UM-HSRI-78-20

A BIOMECHANICAL EVALUATION  
OF NOTICE OF PROPOSED RULE-MAKING  
"STEP, HANDHOLD, AND DECK REQUIREMENTS  
ON COMMERCIAL MOTOR VEHICLES"

[BMCS Docket No. MC-58-1: Notice 78-311].  
F.R. 43(32):6637-6640. February 15, 1978

3 May, 1978

(FOOT CLEARANCE DIMENSIONS (after Chaffin et al, 1978))

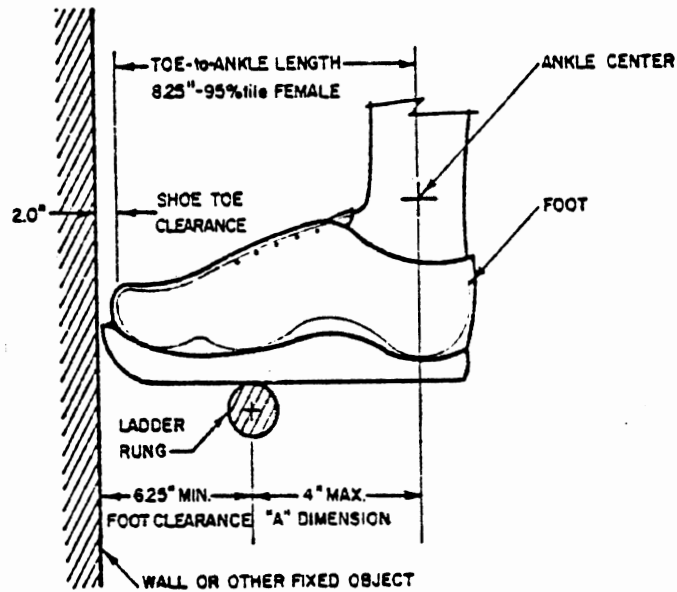
An unpublished study by Chaffin (1978) recommends that toe clearance for ladder rungs be 6.25 in. (based on a large (95th percentile) female foot length. The rationale for this relates to the biomechanics of maintaining the foot in a horizontal orientation when climbing. Muscle fatigue in climbing could lower a person's capability to maintain the desired foot orientation over time, given a 4" movement arm for 95% of women, and 7.5" for 95% of males from the ankle. Dempster (1963) has estimated that the ankle joint lies about 80% of the distance from the top of the greater toe to the most posterior aspect of the heel. This indicates that 95% of women would have toe to ankle lengths no greater than 8.25" (10.3 x .80), and 95% of men would be no greater than 9.0" (11.2 x .80). Randall (1946) has found that wearing a heavy work boot or shoe requires an additional 2" clearance. Thus the minimum foot clearance recommended would be 6.25" based upon a large (95th percentile) female foot length. While this analysis is based upon a steel ladder rung, this would apply directly to cab access steps of similar construction. This analysis assumes the male ankle strengths are sufficient to compensate for their larger moment arms caused by their larger feet. It has been found that a males's plantar extension strength averages twice that of the female (Chaffin, 1978).

The proposed standard does not support why the RP-404 minimum of 5" has been further reduced, and what new data would support a change.

It is concluded that where rails or rungs are used as steps a 2.0 inch clearance is insufficient, and from the sources above 6 1/4 to 7" should be specified.

Figure 7. VERTICAL LADDER AND GRABRAIL SYSTEM.

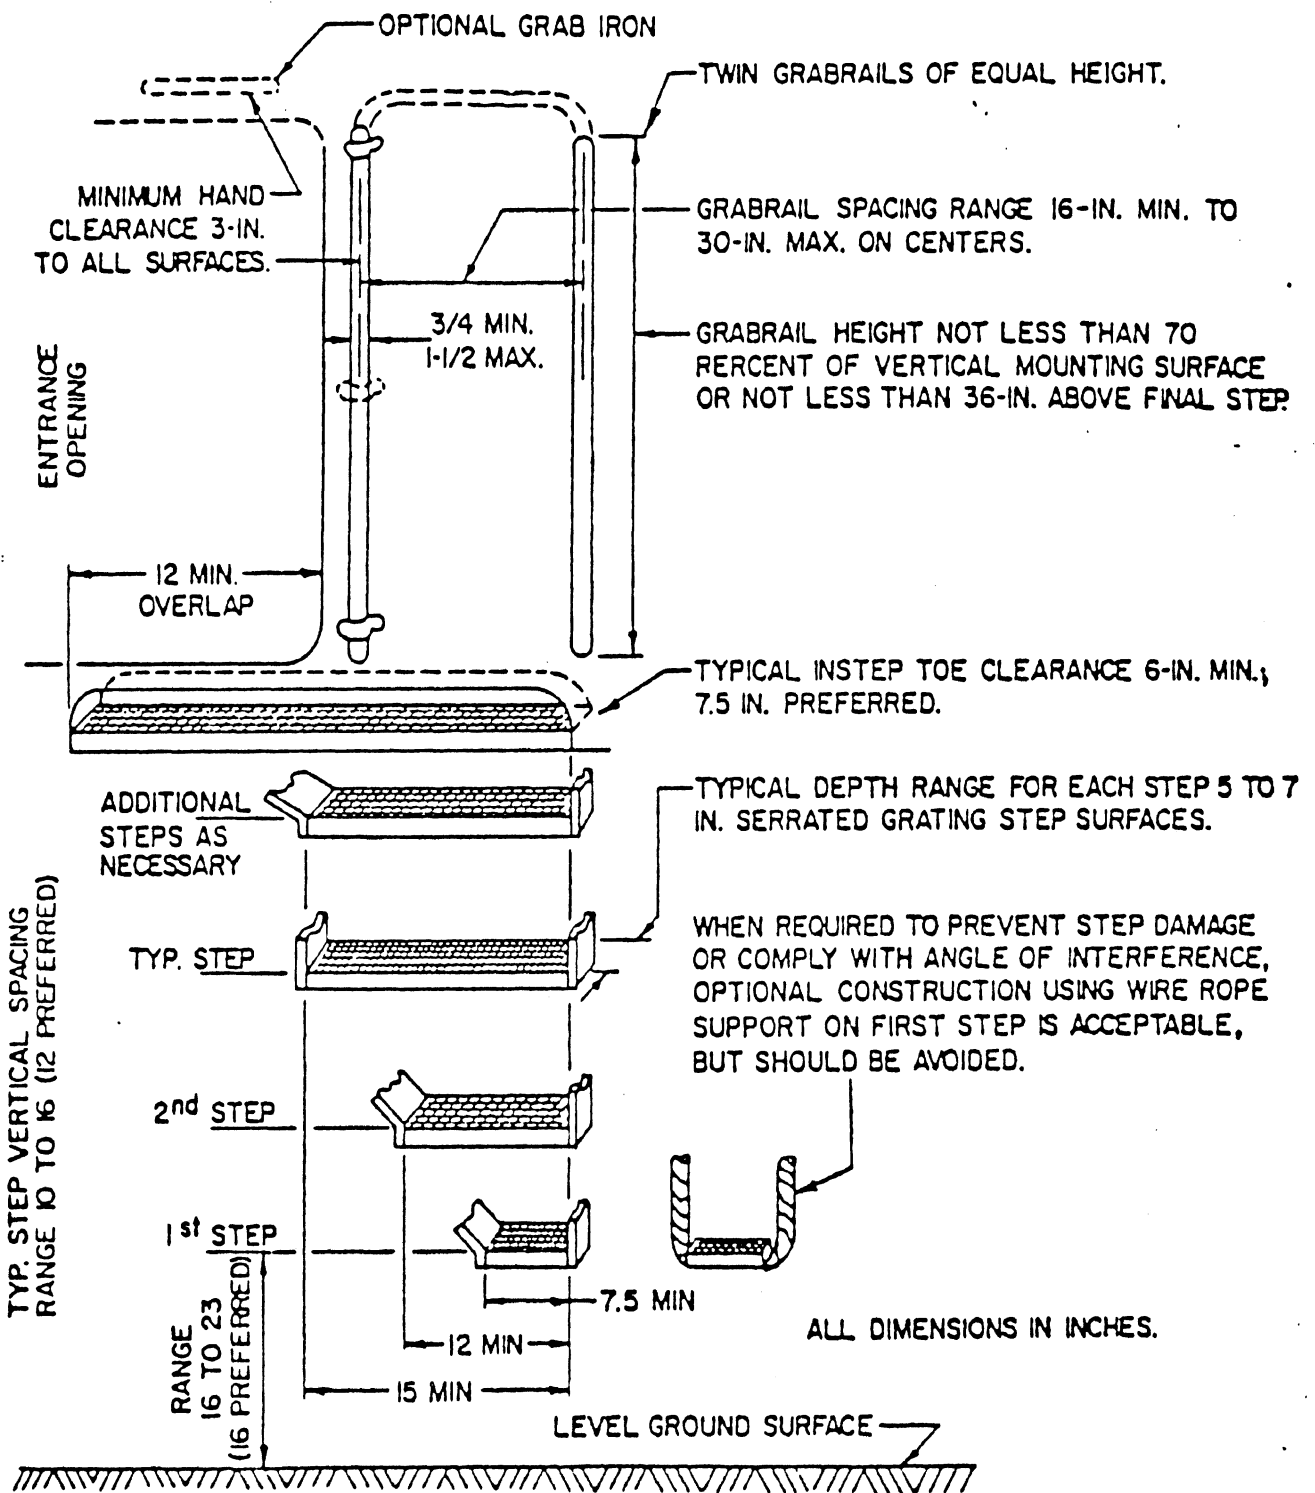
The attached copy of RCCC Recommended Practice RF-404 includes a Figure 7. "Vertical Ladder and Grabrail System" which lists as a source the U.S. Army MERADCOM, Fort Belvoir, Va. This also lists a "range of 16 to 23" inches and notes "(16 preferred)". This reference appears to be identical with Figure 14 "vertical ladder and grabrail system" found in Military Specification Sheet Body, Van, Vehicle-Mounted 150 Size 10, MIL-B-13207/1 (ME) dated 12 August 1976, and approved for use by the USA Mobility Equipment Research and Development Command (MERADCOM)" and is available for use by all Departments and Agencies of the Department of Defense."

RCCC RP-404 Figure 7, and Mil. Spec. MIL-B-13207D(ME) (12 August, 1976) Figure 14, both state that "step vertical spacing range 10 to 16 (12 preferred)". RCC RP-404, in Section 4.2 notes "The maximum distance between steps of vertical ladders on machines shall not exceed 400 mm (16.0 in). The optimum distance between steps based on human factors is 300 mm (12 in.)."

RCCC RF-404, Figure 7, and Mil. Spec. MIL-B-13207D (ME) (12 August, 1976) Figure 14, both state "typical depth range for each step 5 to 7 in. serrated grating step surfaces". RF-404, section 4.6 stated more strongly "The desirable dimension for toe clearance from the outside edge of the step is 180 mm (7 in), and in no case shall it be less than 125 mm (5 in)."

FIGURE 14. VERTICAL LADDER AND GRABRAIL SYSTEM.

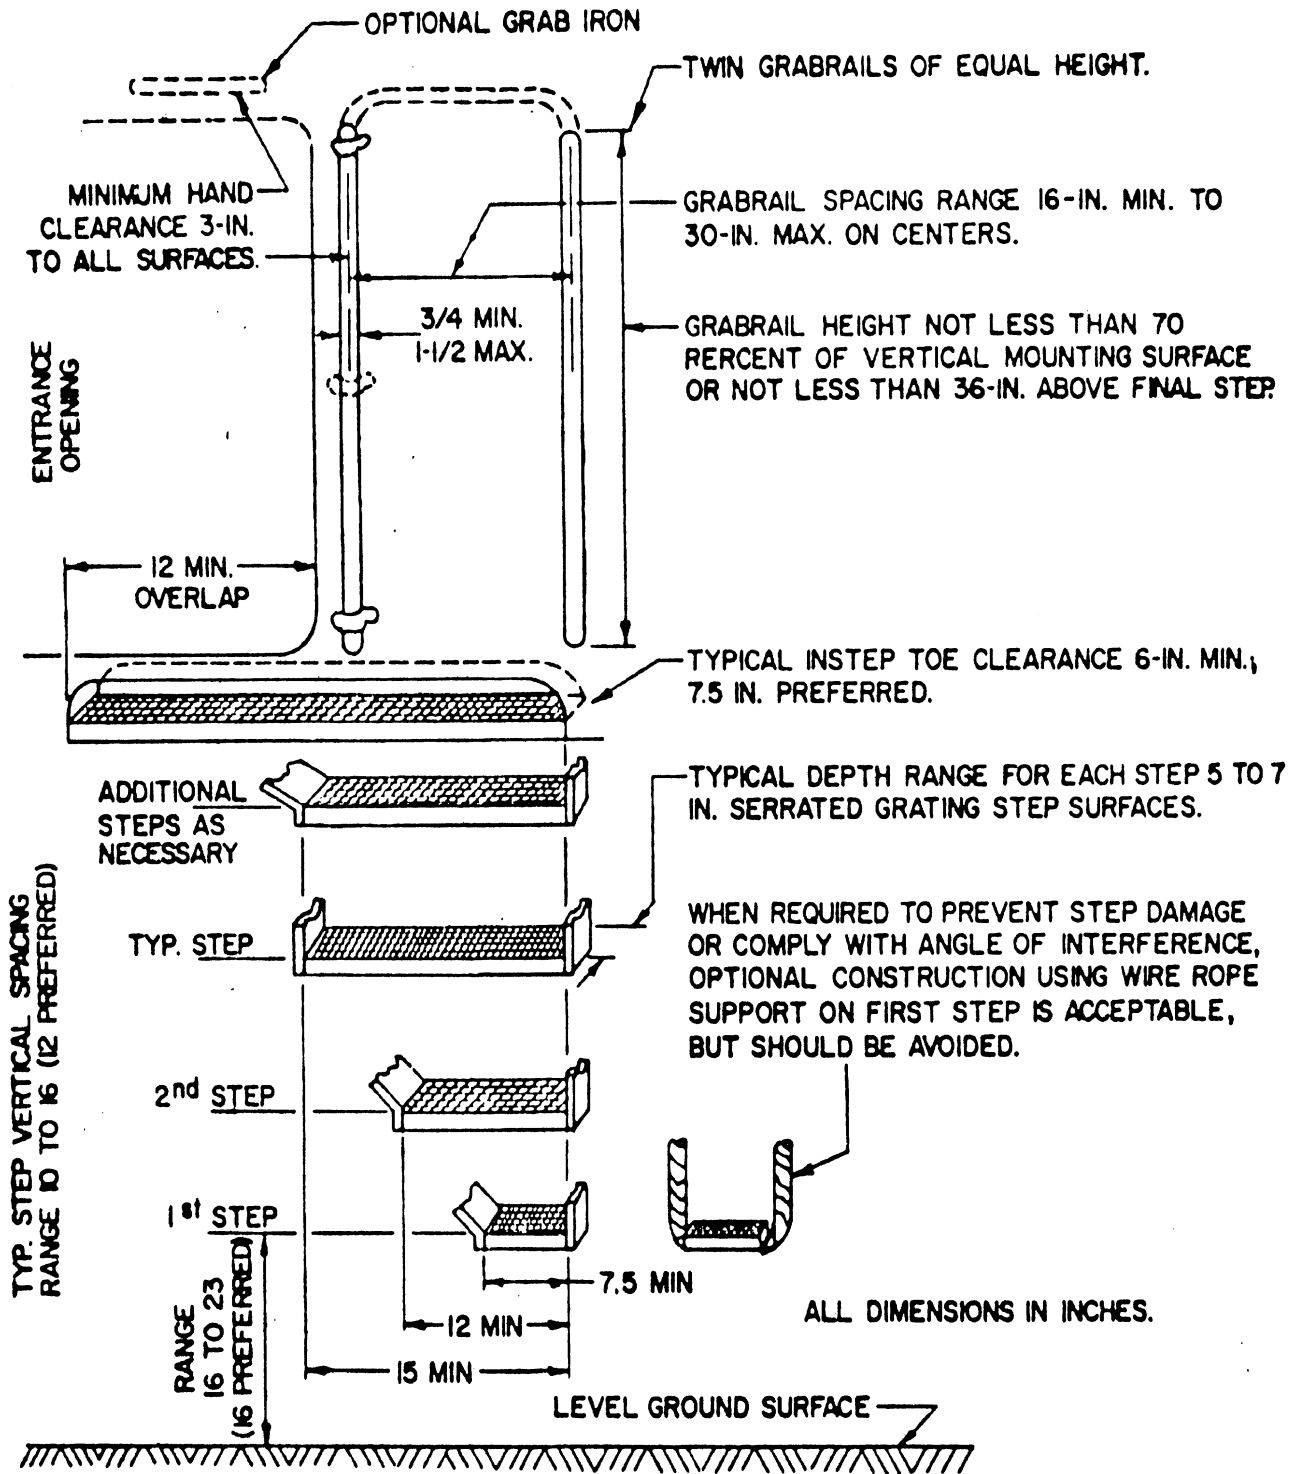
Mil. Spec. MIL-B-13207D (ME), Figure 14, specifies for a 7.5" minimum width first step, 12" minimum step width for the second step, and 15" minimum width above that.
